HENAN XINXIANG 24MW BIOMASS BASED COGENERATION PROJECT

Project Title	Henan Xinxiang 24MW Biomass based Cogeneration Project
Version	02.1
Report ID	01 996 9105073833

Report Title	VCS Verification Report for Henan Xinxiang 24MW Biomass based Cogeneration Project		
Client	Climate Bridge Ltd.		
Pages	34		
Date of Issue	04-09-2013		
Prepared By	TÜV Rheinland (China) Ltd.		
Contact	Unit 707, AVIC Building, No.10B, Central Road, East 3rd Ring Road, Chaoyang District, Beijing 100 022, People's Republic of China Tel.: +86 10 6566 6660 (ext.169) Fax: +86 10 6566 6667 E-mail: doe@chn.tuv.com		
Approved By	Mr. Henri Phan		
Work Carried Out By	Mr. MA Jiandong as team leader	Mr. Walter TANG as technical reviewer	Mr. ZHU Jiang as technical reviewer

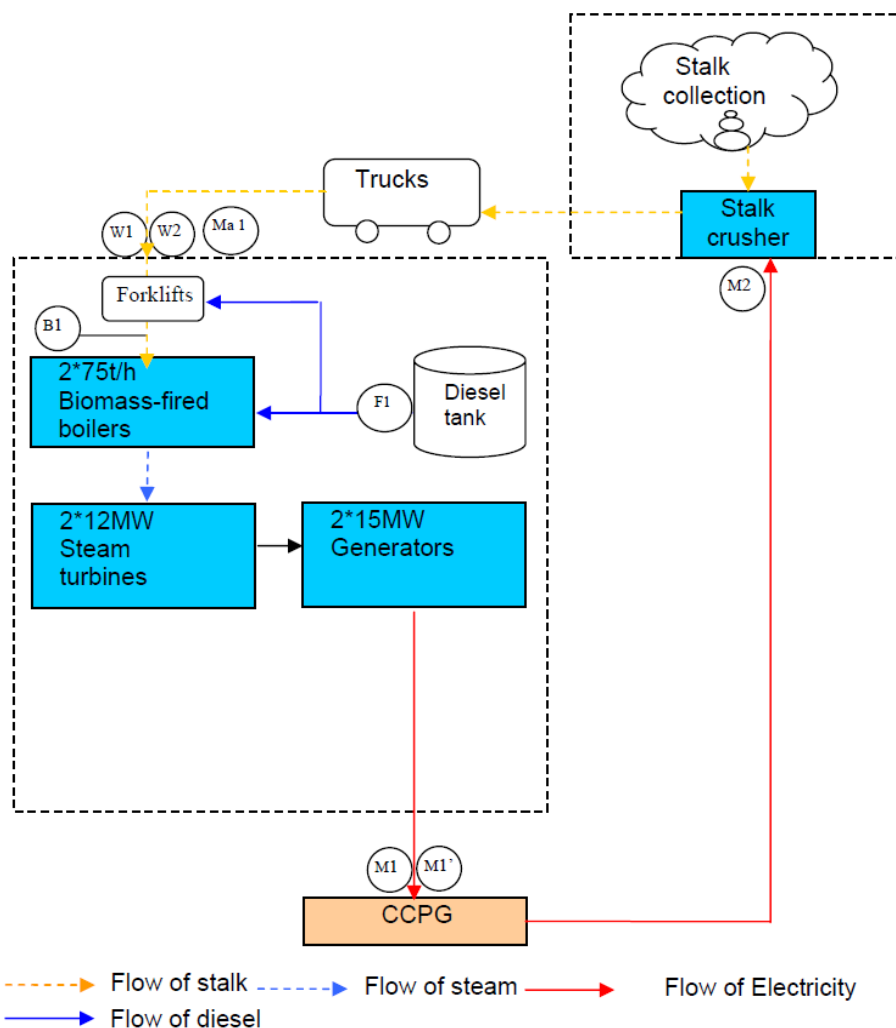
response	conclusion
CL 1	It is found by checking the calibration records of M1 and M1' that the earliest date of calibration is 16 Nov. 2009, so no evidence is demonstrated that the monitoring data of them covering from 28 Oct. 2009 to 15 Nov.2009 is measured by calibrated meters.	MR ER sheet	<p>According to Section 9.4.4.2, Paragraph 238 of Clean Development Mechanism Validation and Verification Standard (version 3.0),</p> <p>“If, during verification of a certain monitoring period, the DOE identifies that the calibration has been delayed and the calibration has been implemented after the monitoring period in consideration (i.e. the results of delayed calibration are available), the DOE may conclude its verification, provided the following conservative approach is adopted in the calculation of emission reductions:</p> <p>(a) Applying the maximum permissible error of the instrument to the measured values taken during the period between the scheduled date of calibration and the actual date of calibration, if the results of the delayed calibration do not show any errors in the measuring equipment, or if the error is smaller than the maximum permissible error; or</p> <p>(b) Applying the error identified in the delayed calibration test, if the error is beyond the maximum permissible error of the measuring equipment.”</p> <p>For this project, the calibration of M1 and M1' has been delayed for couple of days, but the results do not show any errors, therefore, the value of EGimport,y and EGexport,y measured by</p>	<p>It is verified according to VVS version 3.0 that the corrective action for the period from 28 Oct.2009 to 15 Nov.2009 is in line with the CDM requirement regarding delayed calibration.</p> <p>In addition the emission reduction covering the period from 16 Nov. 2009 to 22 Nov.2009 monitored by calibrated meter is deducted by maximal permission error, it is considered conservative.</p> <p>This CL is closed.</p>

M1 and M1' during 28/10/2009 (the scheduled calibration date) to 16/11/2009 (the actual calibration date) have been adjusted by applying the max permissible error of the meters (0.5%).	
--	--	--	--	--
